52020150 Rose Village

MCDOT Reviewer: Brenda Pardo

In an effort to improve our responsiveness and streamline development reviews, we will not be preparing a formal letter for this Concept Plan. These comments reflect MCDOT's official comments on this Concept Plan.

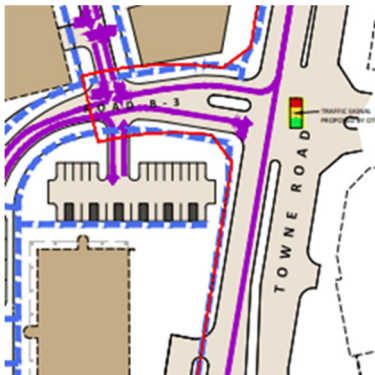
8. Provide a walkway between Existing Office II and Building F to Towne Rd.

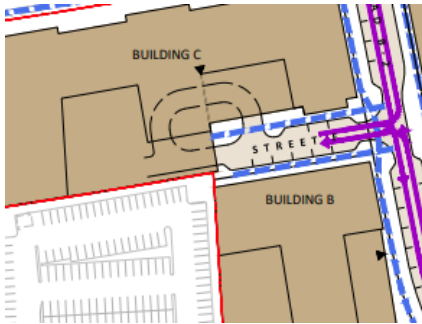
9. Provide a walkway linking the parking lot walkway to Towne Rd.

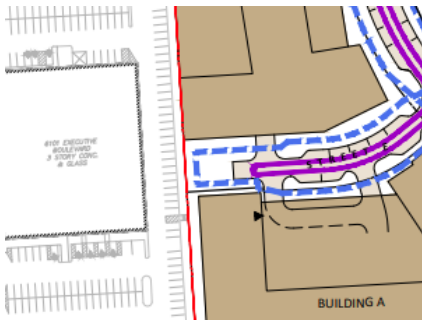
10. Consider a walkway connection from between Buildings B/C to the neighboring property to the west (or at least not preclude a future such connection).
